Access Compliance Report

Public Rights-of-Way

Intersection ID: 29431	Main Street: CASTLE_TERRACE_CT	Cross Street: SHINY_MEADOW_LN	Location: NW
ADA ID: 126B8FDEDB86	Ramp Type: BlendTrans1	Initial Pass/Fail: Fail	Overall Compliance: No
Severity Score: 8.75			
Codes/Mitigation Info/Possible Solution		Field Measurements/Component Compliance

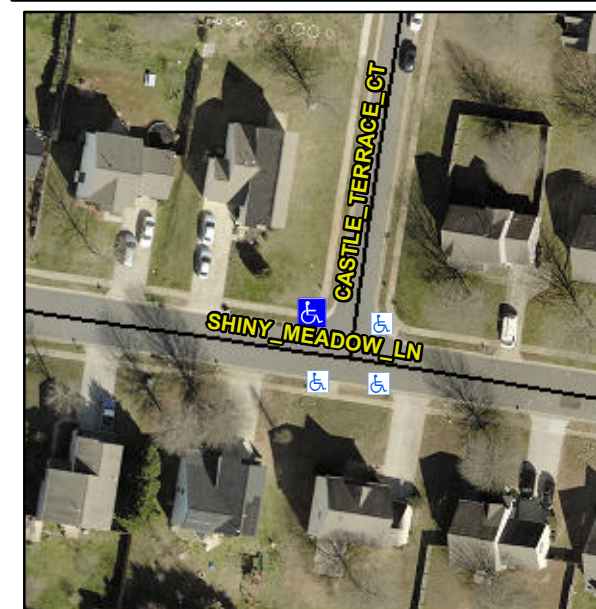
Not Found, R304.5.1

Compliance	Description	Data	Compliance	Description	Data
N/A	Ramp Length (in)	51.0	Yes	BlendTrans Slope (%)	1.6
No	Ramp Width (in)	47.0	Yes	BlendTrans XSlope (%)	1.7
N/A	Flare Type LT	N/A	N/A	Flare Type RT	N/A
N/A	Flare Slope LT (%)	N/A	N/A	Flare Slope RT (%)	N/A
N/A	Flare Traversable LT?	N/A	N/A	Flare Traversable RT?	N/A
N/A	Landing Length (in)	N/A	N/A	DWS Provided?	N/A
N/A	Landing Width (in)	N/A	N/A	DWS Contrast?	N/A
N/A	Landing Slope (%)	N/A	N/A	DWS Length (in)	N/A
N/A	Landing X Slope (%)	N/A	N/A	DWS Full Width?	N/A
N/A	Landing Curb? (Y/N)	N/A	N/A	DWS Offset (in)	N/A
N/A	Shared Landing?	N/A			
N/A	Gutter Ponding?	N/A	N/A	Gutter Slope (%)	N/A
N/A	Gutter Lip Ht (in)	N/A	N/A	Gutter X Slope (%)	N/A
N/A	Painted X Walk1?	No	N/A	Painted X Walk2?	No
	X Walk 1 Direction	To S		X Walk 2 Direction	To E
	X Walk 1 Width (in)	N/A		X Walk 2 Width (in)	N/A
	X Walk 1 Slope (%)	4.9		X Walk 2 Slope (%)	4.7
	X Walk 1 X Slope (%)	2.6		X Walk 2 X Slope (%)	0.4

N/A	Ramp inside XWalk1?	N/A	N/A	Ramp inside XWalk2?	N/A
	Road Slope (%)	0.6		Clear Space?	N/A
	Road X Slope (%)	5.6	N/A	Clear Space to XWalk (in)	N/A
N/A	Any Obstructions?	N/A	N/A	Storm Grate/Utility Hazard?	N/A
	Obstruction Type			Storm Grate/Utility Type	
		N/A			N/A
			Yes	Surface Condition? (G/P)	Good
			No	Curb Slope (%)	10.3

Remove & Replace Curb Ramp With Two New Directional Ramps or Equivalent.
